Field Service Bulletin

This bulletin replaces PV729-FSB356-003 (USA41001) dated 2.2010.

FSB 356-003, Fog Lamp Moisture Intrusion

(October 2013)

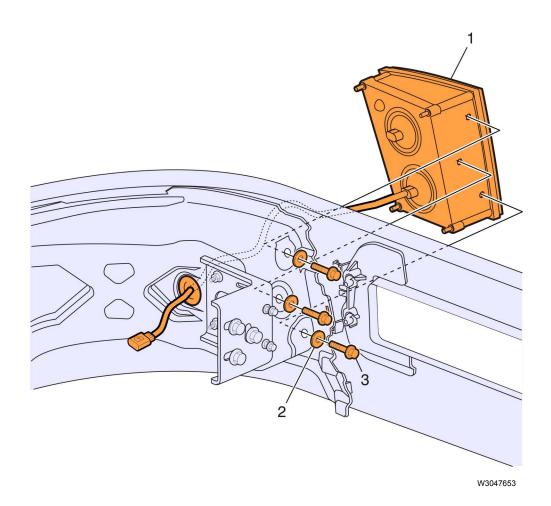
2 Using hand tool only, remove the three (3) mounting bolts.

Note: Do not use pneumatic or high torque electric tools this may cause the captive nuts to spin and crack the fog lamp housing.

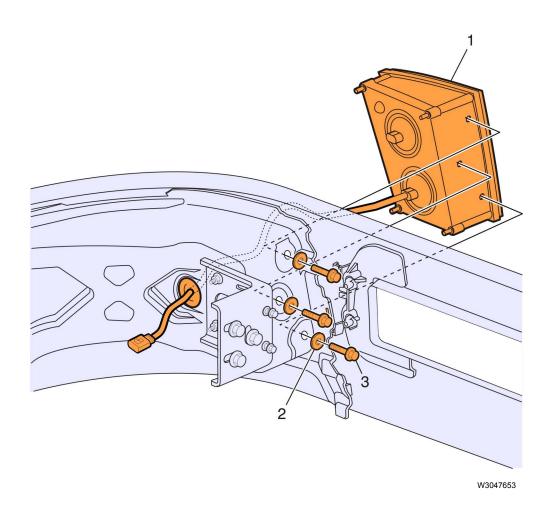
6 Install the bolt finger tight, then using only hand tools torque tighten to 7 Nm (5 ft-lb).
